REVISED 10-26-2015, RFP-13, ADDED COST ITEMS DETAIL

CASE II TRAIL SIGNAGE AND PAVEMENT MARKINGS

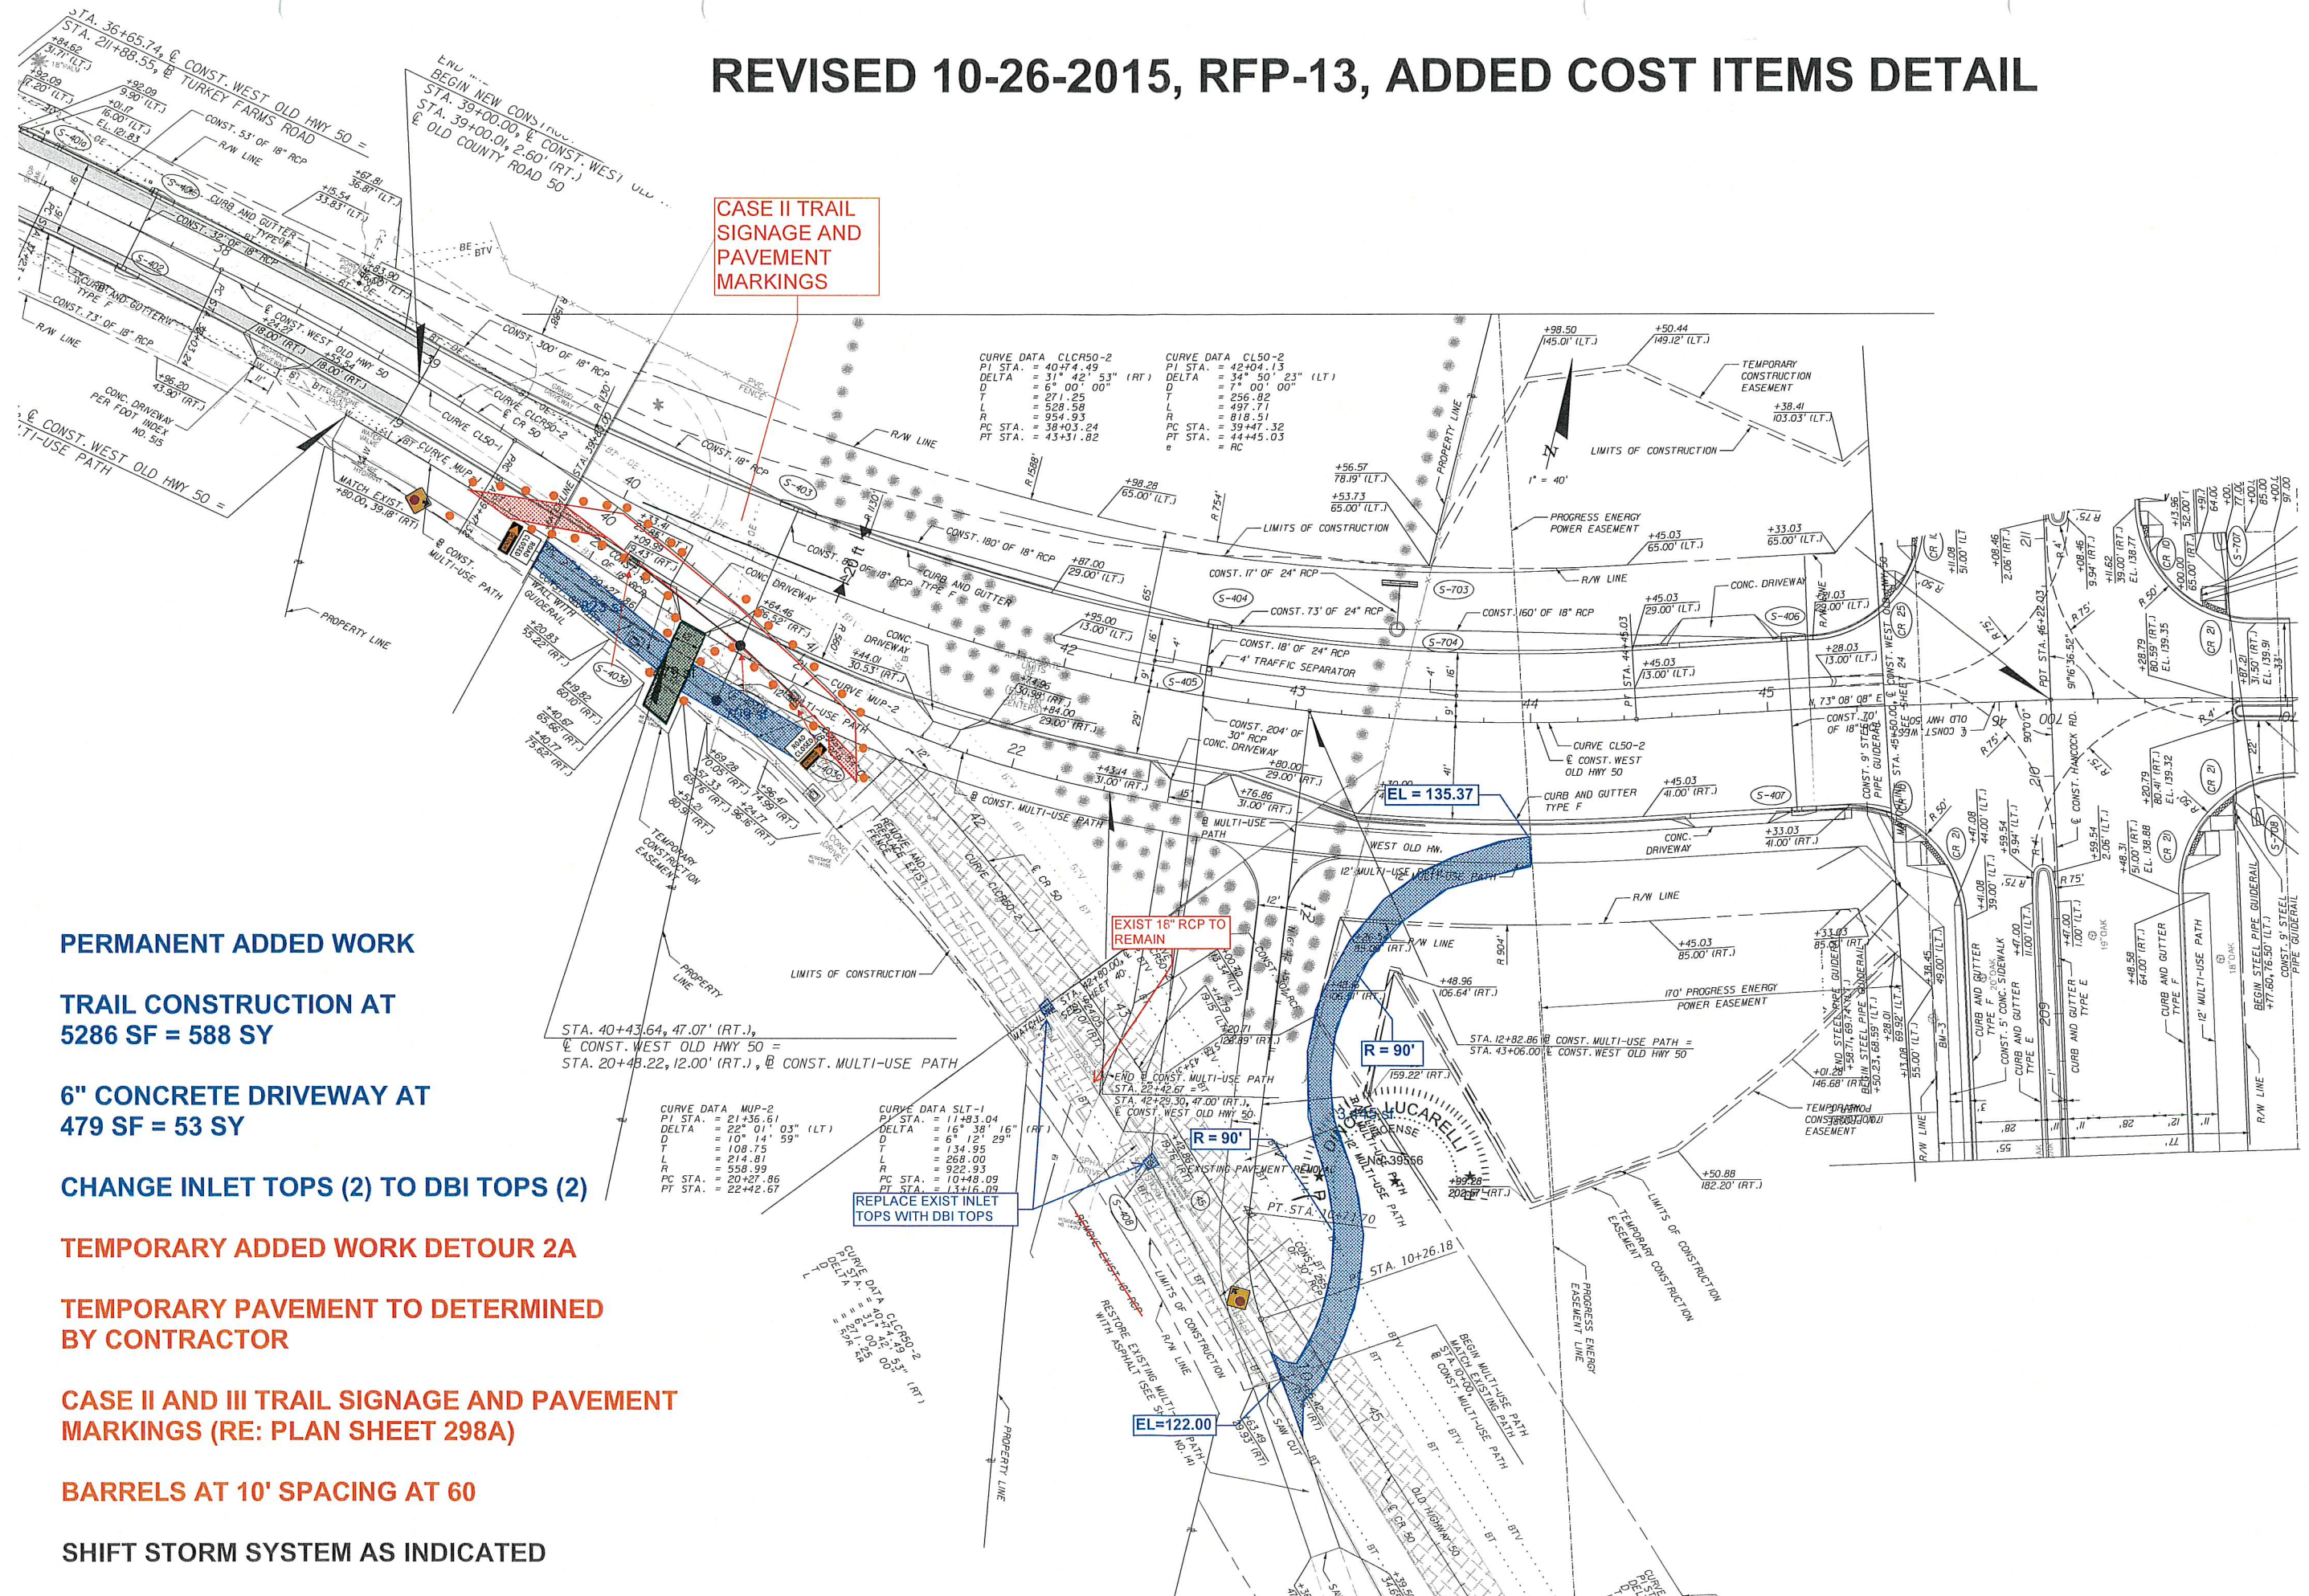
PERMANENT ADDED WORK

TRAIL CONSTRUCTION AT 5286 SF = 588 SY

6" CONCRETE DRIVEWAY AT 479 SF = 53 SY

CHANGE INLET TOPS (2) TO DBI TOPS (2)

TEMPORARY ADDED WORK DETOUR 2A

TEMPORARY PAVEMENT TO DETERMINED BY CONTRACTOR

CASE II AND III TRAIL SIGNAGE AND PAVEMENT MARKINGS (RE: PLAN SHEET 298A)

BARRELS AT 10' SPACING AT 60

SHIFT STORM SYSTEM AS INDICATED

REPLACE EXIST INLET TOPS WITH DBI TOPS
